**Lake Monona Waterfront
Design Challenge
City Technical Team
Review Comments
3/15/2023**

Proposed Law Park Design

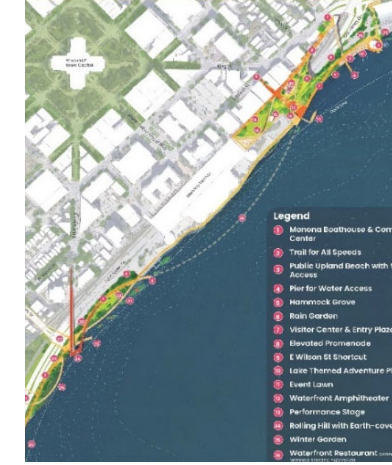
<p>The proposed roadway design in Law Park, north of the Monona Terrace, omits access to the Machinery Row parking lot. The private lot is the off-street parking and delivery location for Machinery Row businesses.</p>	<p>The proposed beach near the Broom Street intersection is along a historically-filled shoreline and the lake bottom drops steeply. This condition requires non-swimmers to stay close to shore.</p>	<p>The proposed pedestrian overpass at the Broom Street intersection will likely obstruct views of the Capitol from the lake shore. It will also provide a jump platform into the lake.</p>
<p>The proposed King Street extension requires removal and redevelopment of three privately-owned properties (155, 307, and 327 E. Wilson Street).</p>	<p>The proposed King Street extension requires removal and redevelopment of three privately-owned properties (155, 307, and 327 E. Wilson Street).</p>	<p>The proposed decking over John Nolen Drive north of the Monona Terrace will obstruct two floors of existing condominium units at 155 E. Wilson Street.</p>

<p>The King and Hamilton Street pedestrian overpass structures may create jump platforms into the lake.</p>	<p>It appears the proposed development of Law Park north of the Monona Terrace does not include an access ramp for emergency boat services (identified in the Preliminary Report).</p>	<p>The route of the multi-use path south of the Monona Terrace isn't clearly defined.</p>
<p>The proposed Monona Hill appears to show that people on bikes would need to ride up it to stay on the path. Many people on bikes will not want to ride up the path and will instead use the boardwalk unless they are heading to MLK (which seems like it will connect). Recreational riders will likely want to stay along the water especially visitors.</p>	<p>The proposed decking over John Nolen Drive north of the Monona Terrace will obstruct two floors of existing condominium units at 155 E. Wilson Street.</p>	<p>It is not clear if the Visitor Center & Entry Plaza bridge is high enough to clear the railway line. It also appears to have a large stair with no accessible route.</p>

<p>The proposed beach at King Street conflicts with an existing fishery habitat (identified in the Preliminary report. The design and extent of the beach area must avoid disturbing this sensitive environmental system.</p>	<p>The proposed beach north of the Monona Terrace conflicts with an existing fishery habitat (identified in the Preliminary report. The design and extent of the beach area must avoid disturbing this sensitive environmental system.</p>
<p>Some of the graphics seem to show that people will both walk and bike on separate paths on Monona Hill & the waterfront area is for "strolling" so not sure what that means for usage. There does seem to be a lowered path as well in a graphic but not sure how that would work. Is it in the tunnel? What would that be like - motor vehicle fumes might be a real concern.</p>	<p>Removing John Nolen Drive vehicle lanes north of the Monona Terrace will cause significant disruption to traffic flow, given current traffic volumes.</p>	<p>The elevated waterfront park concept is interesting but wonder how this would work from a walking/biking perspective as well as accessibility.</p>

<p>The plan does not provide the pork chop island at Williamson St. A previous study explored omitting the island, and there were problems with not being able to separate the pedestrian walk indication from the right turn signal. The King Street pier structure may create a jump platform into the lake.</p>	<p>The Overlook at Hamilton street could become a jumping platform into the lake.</p>

Proposed Law Park Design (cont.)

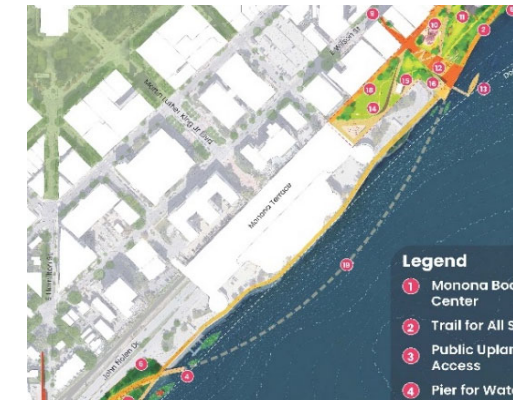
Agency Landscape + Planning	James Corner Field Operations
<p>Will there be an easy way for people on bikes to reach the overlooks and sitting space without creating additional conflicts? Will there be space for people to park their bikes to enjoy those amenities or would then need to park at either end of the causeway to do that?</p>	<p>Broom St cul de sac - need to ensure that the path crossing is well designed so that people driving in to pickup or drop-off (especially people from out of town) are yielding and driving safely.</p>
<p>Will need to ensure the overpasses work for flow both on/off and through the area as the transitions can be tricky. The graphic shows lots of different potential movements that would need to be well thought out to minimize conflicts between users as someone will be just moving through and others will be just looking around enjoying the views and trying to figure out where they want to go.</p>	<p>Like the idea of improving and separating the fishing area near Lake Monona although this approach may have some challenges and logistical issues</p> <p>It is not clear how the footbridge at Hamilton St is envisioned to work - is there an elevator down? How will it be accessible? How are bikes accommodated?</p> <p>The plan renderings extend beyond the project boundaries, making the available area look larger than it is.</p>

<p>See Monona Terrace comments.</p>	<p>The connection to the proposed King Street pier includes multiple sets of stairs with no clear accessible route.</p>
	<p>The proposed dog run is on top of Madison Water Utility well #17, which is critical to the city water supply. Well and pump station access must be maintained with any proposed improvements.</p> <p>See Monona Terrace comments.</p>

Proposed Monona Terrace Changes

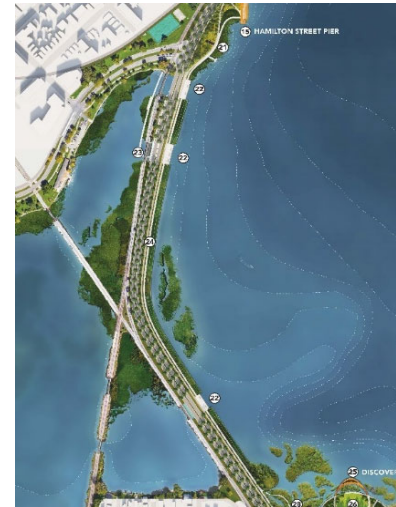
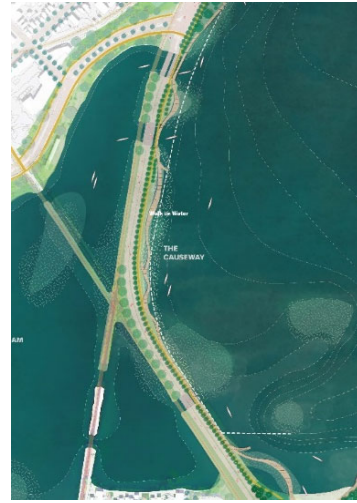
<p>Any proposed changes to the Monona Terrace are the purview of the Monona Terrace Board and management team. The Monona Terrace is a Frank Lloyd Wright structure, and proposed modifications must maintain this designation. Any changes will likely require review by the Frank Lloyd Wright Foundation in addition to the Terrace Board.</p>	<p>Any proposed changes to the Monona Terrace are the purview of the Monona Terrace Board and management team. The Monona Terrace is a designated Frank Lloyd Wright structure, and proposed modifications must maintain this designation. Any changes will likely require review by the Frank Lloyd Wright Foundation in addition to the Terrace Board.</p>	<p>The proposed master plan works with existing Monona Terrace and accommodates the future expansion zone.</p>
<p>The hill greatly detracts from the signature Monona Terrace and the iconic view ("postcard view" as it is called in the Downtown Plan). It covers too much of the building and seems to visually disconnect it from the Downtown.</p>	<p>It appears the proposed the fishing platform at lake-level extends beyond the State-determined limit for shoreline improvements (Buildable Dockline per the Preliminary Report).</p>

<p>The steepness of the hill will likely make many parts of the area inaccessible. The Bike/pedestrian overpasses down Hamilton/King back up the rear of Monona Terrace are confusing (They seem to go down and then back up to the center of Monona Terrace which would be more easily accessible from MLK Jr. Blvd)</p>	<p>The wall along the bike path helped protect the first floor of the Terrace from flooding in 2018. Pumps and sandbags were placed at the end of the wall to keep flood water from entering the facility. The proposed design removes this feature.</p>	
<p>It appears the proposed multi-use path requires users to climb up to the Monona Terrace elevation and then back down again.</p>

**Proposed John Nolen Drive -
Northshore Drive to Lakeside Street
Design**

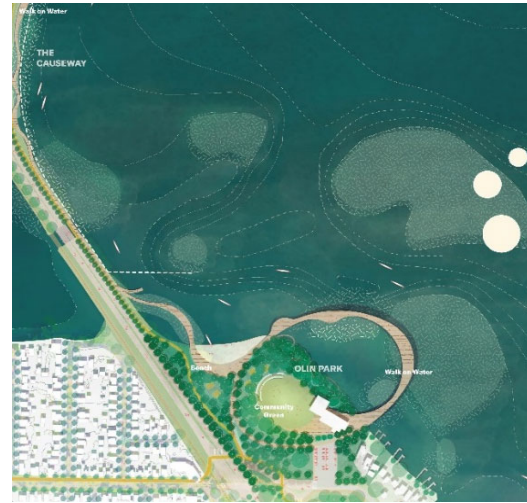
Agency Landscape + Planning	James Corner Field Operations	Sasaki
<p>The proposed master plan works with current plans for the reconstruction of John Nolen Drive and the Blair Street intersection.</p>	<p>The plan does not provide left turn lanes for north-bound John Nolen Drive to Northshore, or north-bound John Nolen Drive to Broom. These are major entrances to downtown and will need some type of accommodation for left turns.</p>	<p>The proposed master plan works with current plans for the reconstruction of John Nolen Drive and the Blair Street intersection.</p>
<p>The narrowed median is consistent with the public feedback received at the 02/23/23 PIM. The proposed master plan appears to work with current plans for the reconstruction of the John Nolen Drive causeway.</p>	<p>The proposed heavy tree planting along the causeway will block the iconic views ("postcard views" as stated in the Downtown Plan) of the capitol and skyline. The anticipated roadway median width is not sufficient to support full-size canopy trees.</p>	<p>The narrowed median is consistent with the public feedback received at the 02/23/23 PIM. The proposed master plan appears to work with current plans for the reconstruction of the John Nolen Drive causeway.</p>

<p>How will the new wetlands/marsh impact the overall walk/bike experience? Will it improve the health of the lake enough that this won't be an area where trash collects and where in the summer the lake has an unpleasant aroma? Want to make sure this is also an enjoyable experience year round.</p>	<p>The narrowed roadway median is consistent with the public feedback received at the 02/23/23 PIM. Note - the narrow roadway media increases the space along the causeway for pedestrians, cyclists, and shore access. However, it does not provide sufficient area for media trees. The proposed row of street trees isn't feasible with the anticipated roadway alignment.</p>	
	<p>How will the new wetlands/marsh impact the overall walk/bike experience? Will it improve the health of the lake enough that this won't be an area where trash collects and where in the summer the lake has an unpleasant aroma? Want to make sure this is also an enjoyable experience year round.</p>

<p>The propose footbridge along the causeway connecting people to Brittingham Park requires further evaluation. The proposed route under the causeway and railroad bridges will be below lake level.</p>

Proposed Olin Park Design

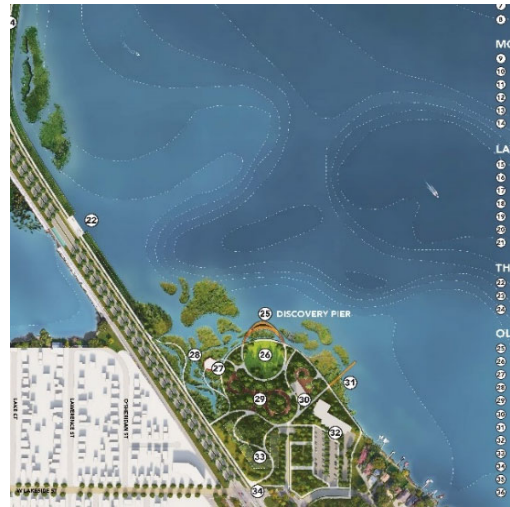
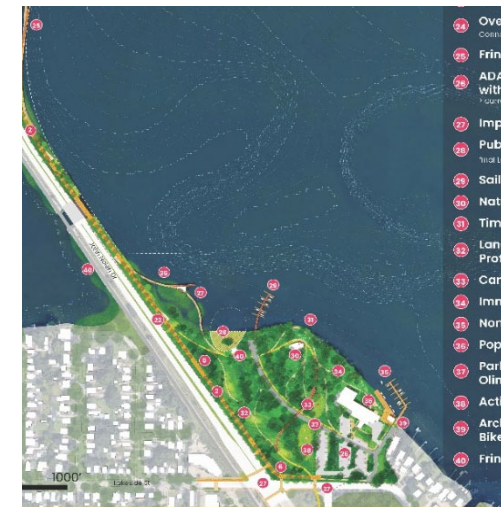
<p>The proposed circular boardwalk appears to prohibit watercraft access to it's interior and the park lakeshore. Lake Monona is a public waterway, and dock and boardwalk features cannot limit lake access.</p>	<p>The proposed "learn-to-kayak" course and islands are in a zone with very little lake current. Algae, floating vegetation and lake debris will collect in this area. There is concern the plan will create stagnant back water areas.</p>	<p>The proposed beach location at Olin Park is near an underwater shelf of submergent vegetation. The shelf is a fishery habitat zone, and the design and extent of the beach area must avoid disturbing this sensitive environmental system.</p>
<p>The proposed beach location at Olin Park is near an underwater shelf of submergent vegetation. The shelf is a fishery habitat zone, and the design and extent of the beach area must avoid disturbing this sensitive environmental system.</p>	<p>The proposed land reduction for the kayak course removes an iconic viewing spot of downtown Madison.</p>	<p>The proposed beach at Olin Park is in a zone with very little lake current. Algae and other lake vegetation accumulate in this area during the summer months.</p>

<p>The proposed beach at Olin Park is in a zone with very little lake current. Algae and other lake vegetation accumulate in this area during the summer months.</p>	<p>The proposed dock/boat rental location is at a very steep section of shoreline, with a 20 ft. plus drop to the water.</p>	<p>Like the concept of the tree canopy walk, but have concerns on feasibility. How is access provided? What are the connection points? Will it be available in winter?</p>
<p>Support the idea of having interpretive information along a path. This likely will also attract people on bikes especially families and visitors. Have concerns this will cause conflict/strife between users. Is there a way to make that work if people are biking slowly or would it just need to be signed for walking only and have good bike parking? That does raise issues over space to pull over and look at the signage if slow bicycle traffic is allowed.</p>

<p>The bike path and pedestrian path in Olin Park is one area where the paths diverge the most and there is likely to be people walking/biking on both. People walking may want a more direct path and people biking may want to visit the beach, the community green, the spectator space, etc. How is this envisioned to work? Also, the word "fast" is not a great choice since people biking, scootering, etc. are traveling at varied speeds and also have conflicts.</p>
